COYOTE CREEK MINING COMPANY, L.L.C.

RE: Notice of Violation Number 1601 – Response to NDPSC Letter Dated August 11, 2016

Enclosed is Coyote Creek Mining Company, L.L.C.'s (Coyote Creek) response to your letter dated August 11, 2016 requesting additional information on our remedial action steps in Notice of Violation (NOV) Number 1601.

Discharge Point 9

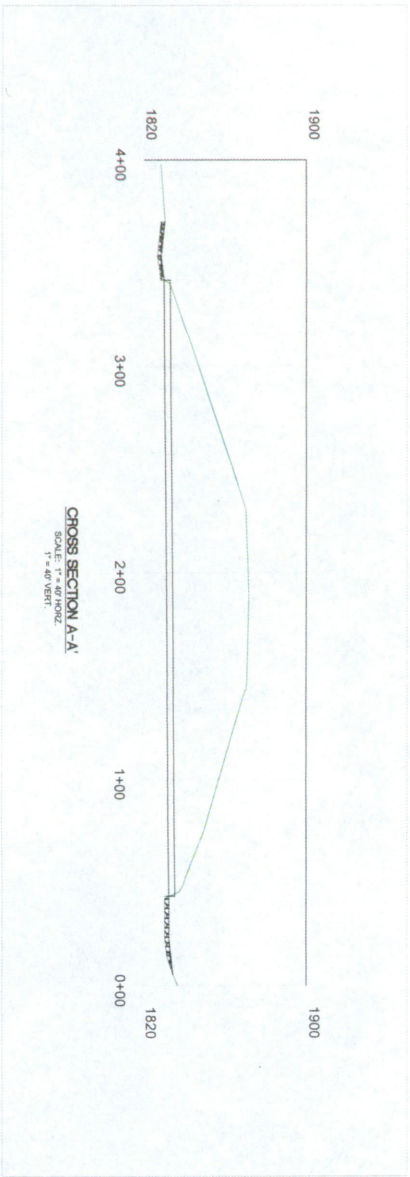
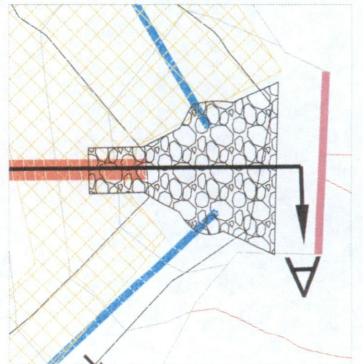
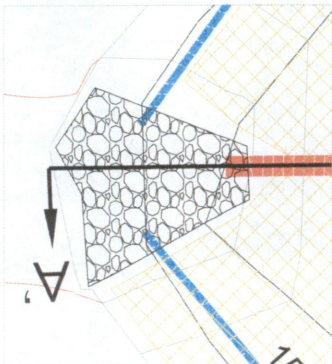
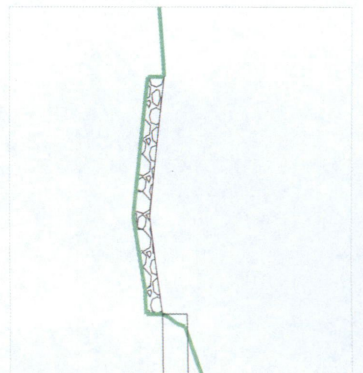
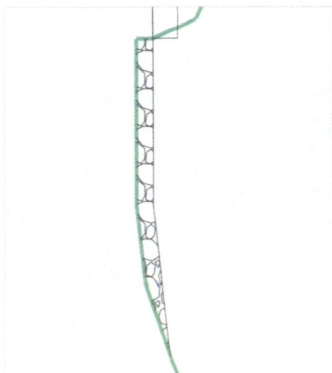
2. "Please provide plan and profile drawings with dimensions for the erosion protection for the culvert and pipe inlets and outlets associated with discharge points 9 and 12."

Plan and profile drawings are enclosed for the requested discharge points.
